Commonwealth Edison
 One First National Plaza, Chicago, Illinois
 Address Reply to: Post Office Box 767
 Chicago, Illinois 60690

Subject: Proposed Change of the Maximum Allowable In-Sequence Control Rod Worth Permitted by the Technical Specifications for Dresden Unit 3, AEC Dkt 50-249

TECHNICAL BASIS FOR CHANGES TO
ALLOWABLE ROD WORTH SPECIFIED

TECHNICAL SPECIFICATION 3.3.B.3 (a)

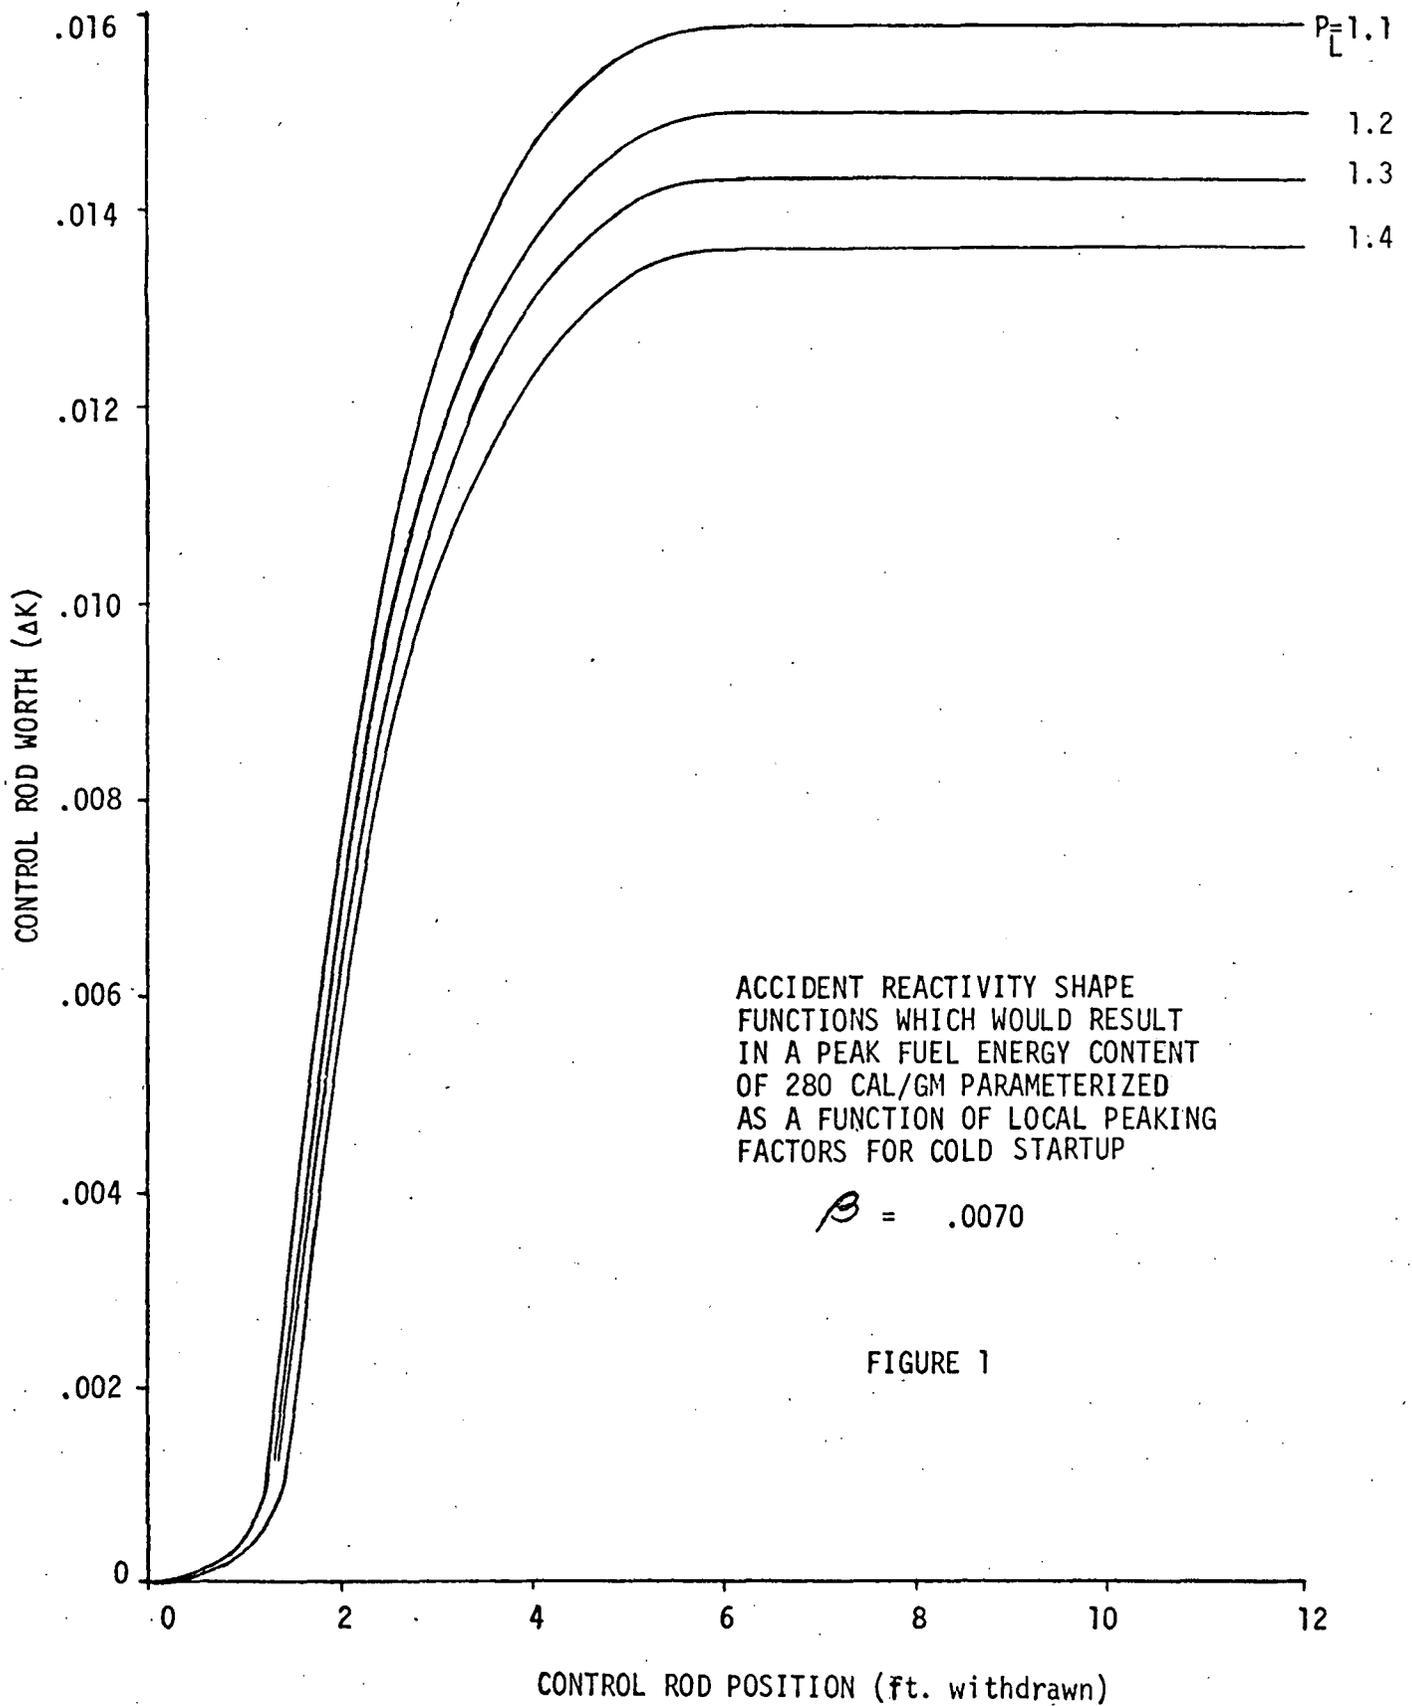
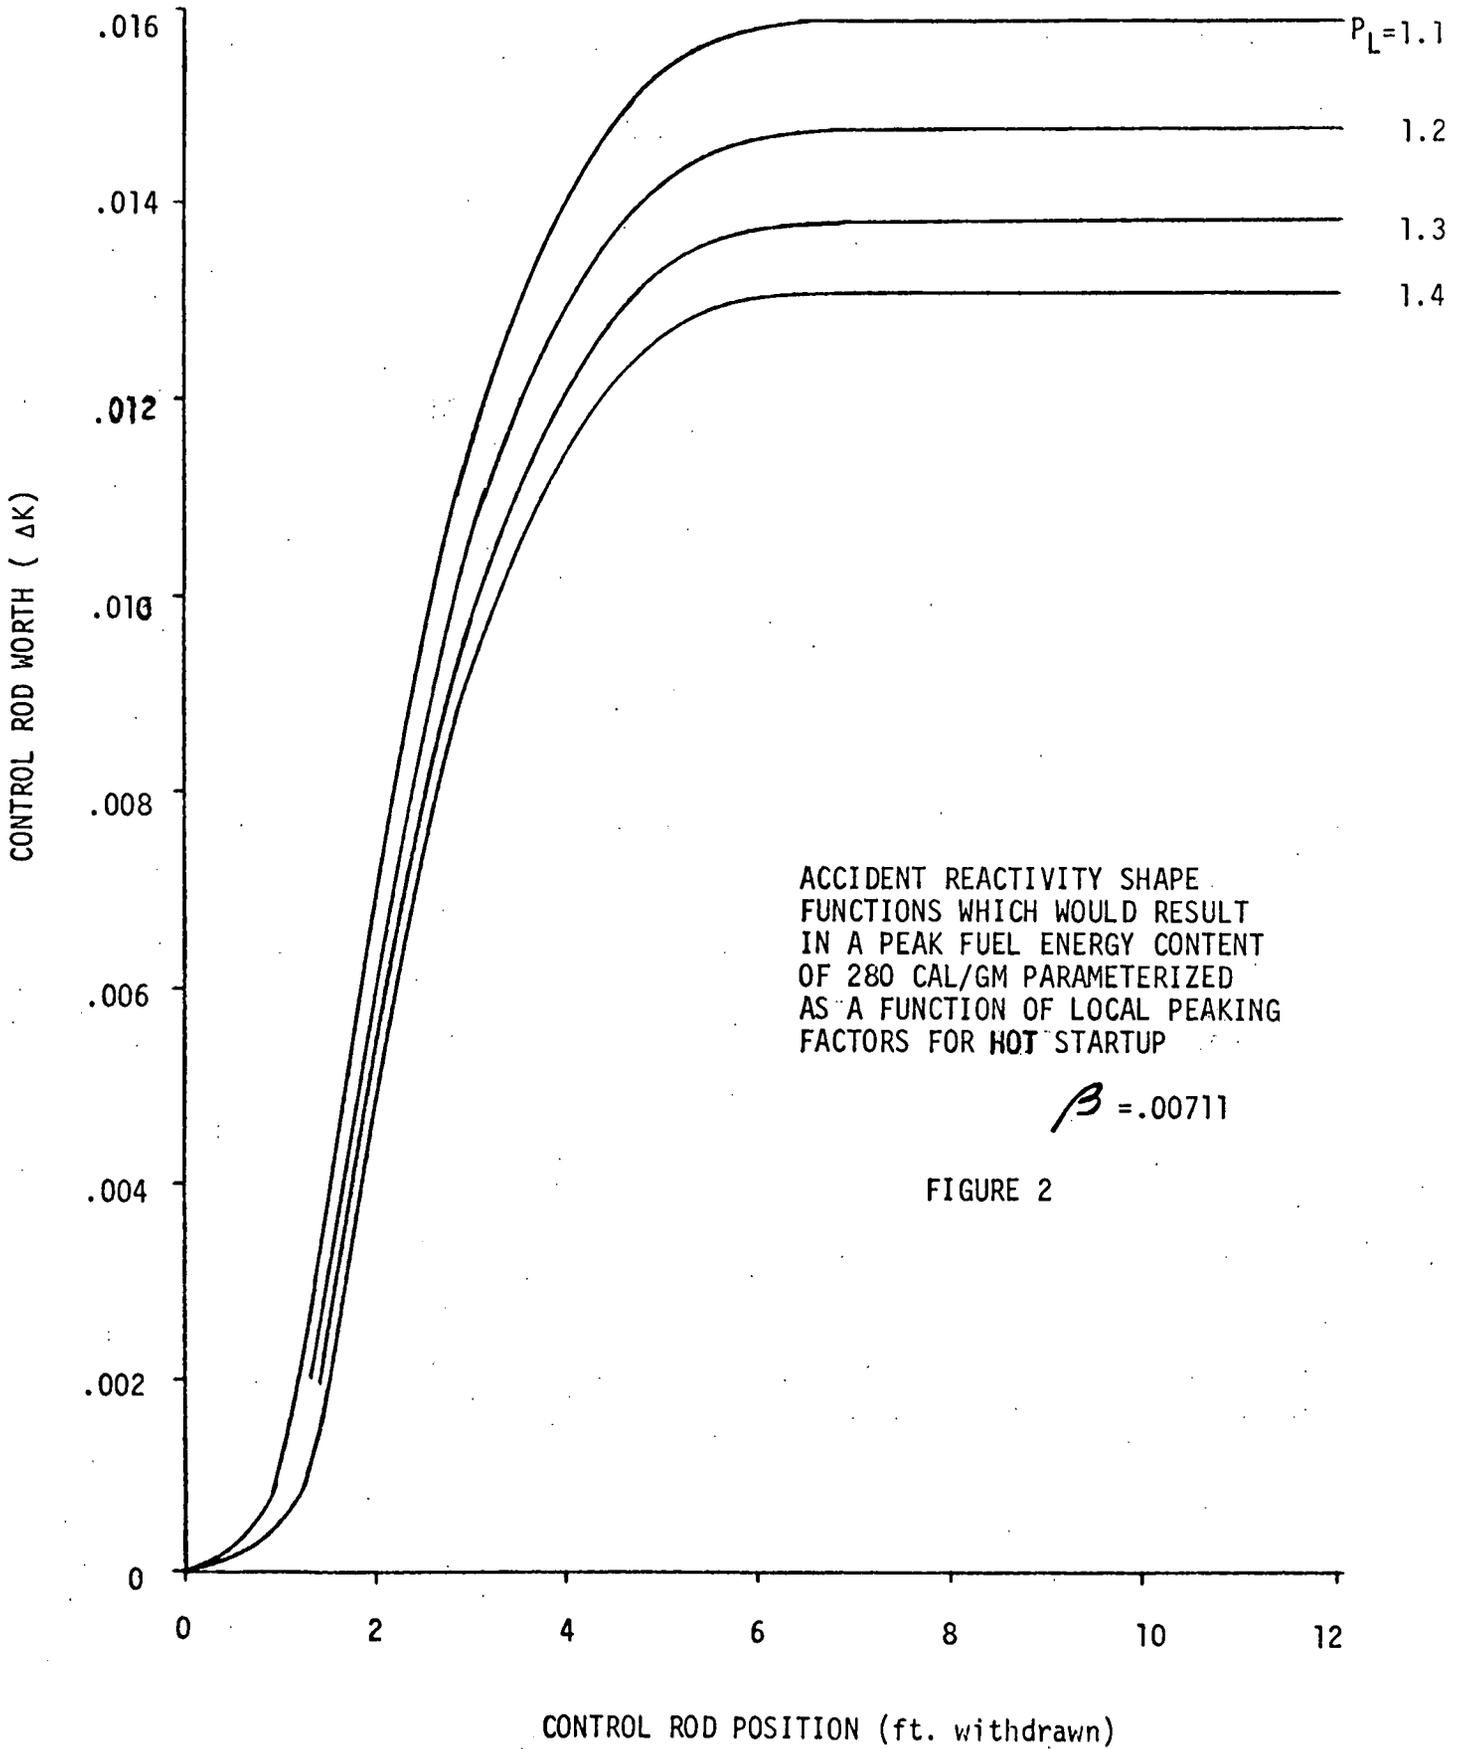
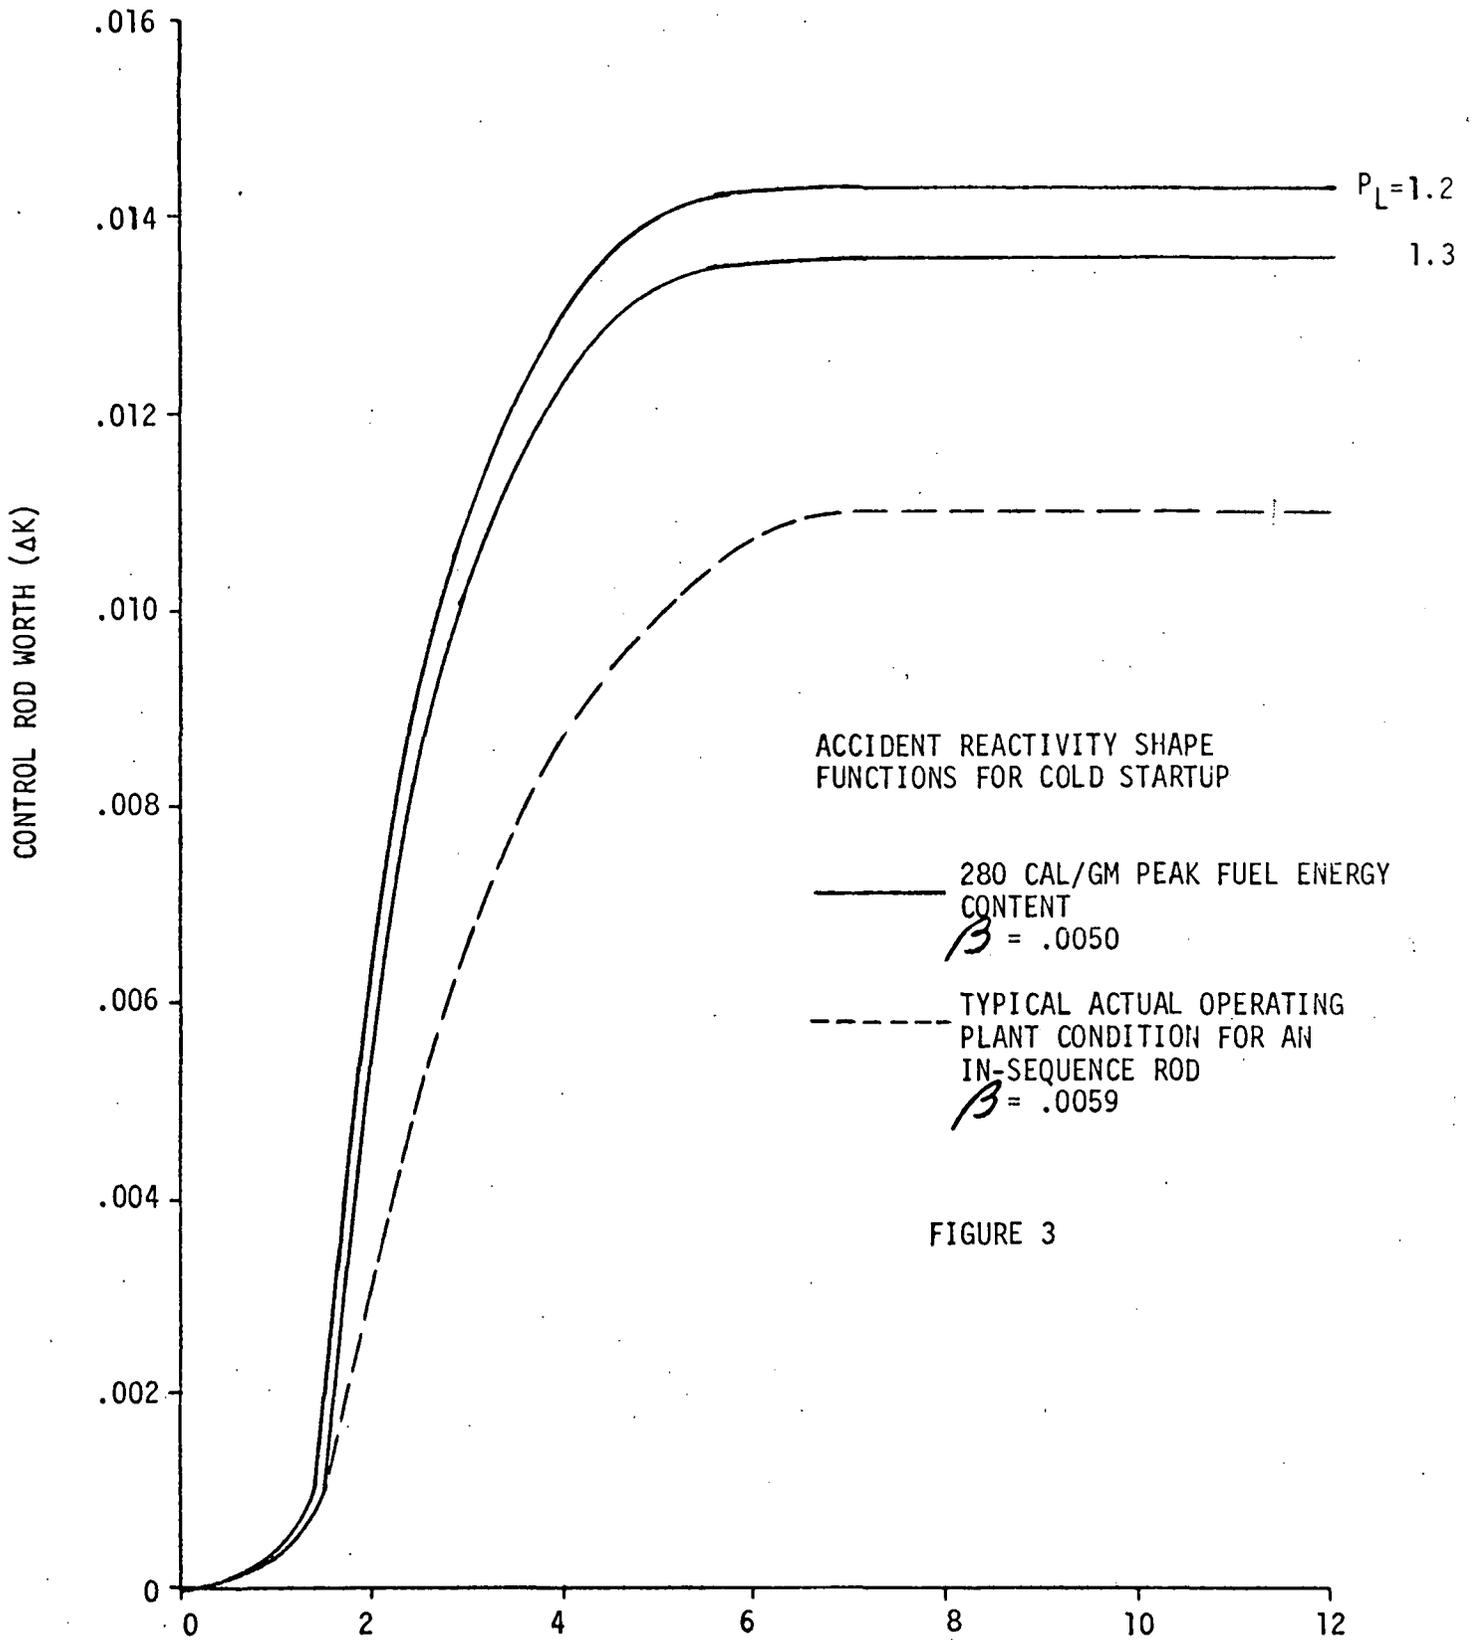
The sensitivity of the rod drop accident to the first three parameters at cold startup and hot startup are shown by Figures 1 and 2 and the effect of the delayed neutron fraction (β) can be seen by comparing Figures 1 and 2 with Figures 3 and 4 respectively. To determine whether or not a specific condition will meet the 280 cal./gm design limit at cold startup or hot startup, the accident reactivity characteristics (i.e., accident shape function, local peaking, etc.) for the plant being analyzed should be matched to those presented in Figures 1 through 5. If the accident reactivity characteristic curves are equal to or less than those shown as solid lines in Figures 1 through 4, then one of the three conditions needed to conservatively ensure RDA peak fuel enthalpy equal to or less than 280 cal/gm is satisfied. If the actual plant accident reactivity characteristics are greater, a more detailed analysis would have to be performed.

Some example curves resulting from calculations with operating plant data are also plotted as dotted lines on Figures 3 and 4 to demonstrate compliance with the condition, including the

one with the highest k_{eff} . Other data (not plotted to avoid confusion) are shown in Table 1. Comparisons have been made on Figures 3 and 4 because the betas most closely coincide. The beta for Figures 1 and 2 correspond to Beginning-of-Life (BOL) conditions which no longer exist for operating plants.

Although the betas associated with the operating plant curves are not precisely the same as the value used for the 280 cal/gm boundary curves, the differences are in the conservative direction.

As shown in Table I, betas for operating plant conditions are generally higher than those used in Figures 3 and 4 for the 280 cal/gm boundary curves, thus allowing higher $P_{L's}$ or rod worths within the boundary.
